STAFF REPORT

HISTORIC DOWNTOWN ADVISORY COMMISSION

Applicant: Mathew Althouse for Dustin Sun
Location: 26 W Olentangy Street
Existing Zoning: Downtown Business District (DB)
Request: To review a proposal to change the previously approved front elevation of the building.

1
A2.1 EXTERIOR ELEVATION - SOUTH
1/4" = 1'-0"

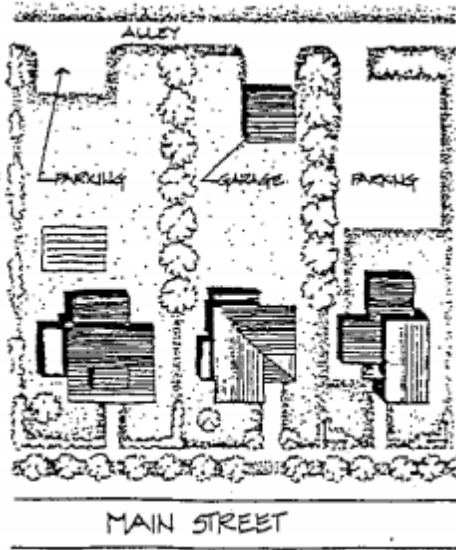
- The proposed project is in line with site considerations of the PAG.
 - Access to rear yard parking lots and storage or garage buildings should be from alleys whenever possible.
 - The proposal has designed their parking lot in this fashion.
 - Commercial lots should be paved with asphalt, brick, concrete, or tar and chips as required in the Powell Zoning Code.
 - Renderings show an asphalt type of pavement.

RIBBON WINDOW

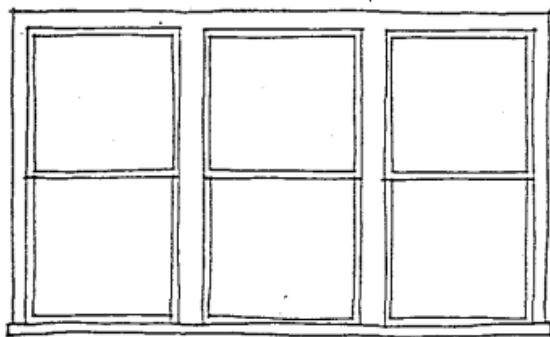
- The proposed project is somewhat in line with the PAG.
 - The front elevation of the proposal displays the Ribbon style, one of the three historically correct window styles with a 2-over-2 pattern. (Page 48)
 - Further examination by the Powell Architectural Advisor and HDAC is needed to determine whether the panels above the front windows are appropriate.
